Additions and Corrections

The following presents additional information and technical errors found between June 15, 2016, and October 11, 2019, in the I-P editions of the 2016, 2017, 2018, and 2019 *ASHRAE Handbook* volumes. Occasional typographical errors and nonstandard symbol labels will be corrected in future volumes. The most current list of Handbook additions and corrections is on the ASHRAE web site (www.ashrae.org).

Fig. 10 Approximate Groundwater Temperature (°F) in the Continental United States
(from 2019 Applications, p. 35.11)

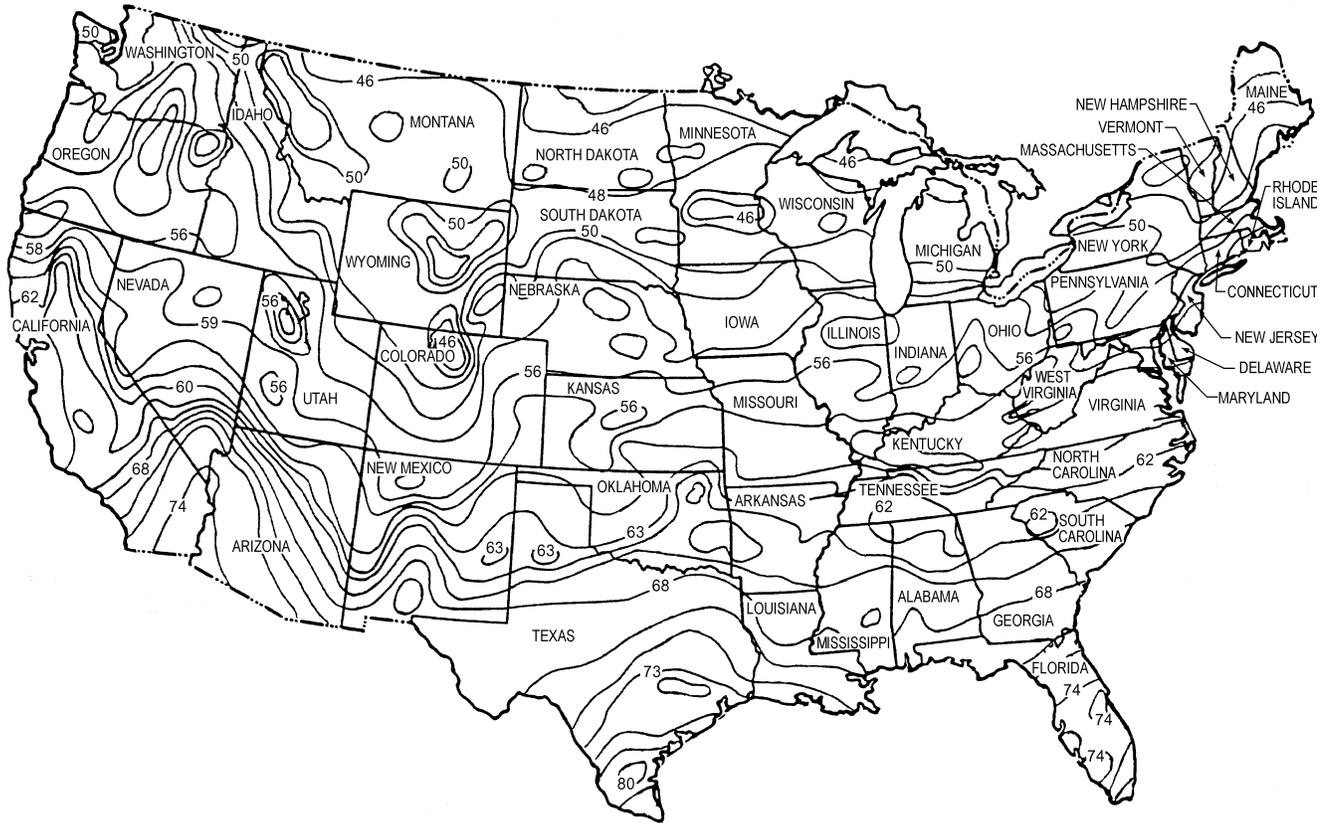
p. 35.11, Fig. 10. SI version of Figure 10 was included in both the I-P and SI versions of the chapter. Correct I-P graphic is as seen at the top of page A.2.
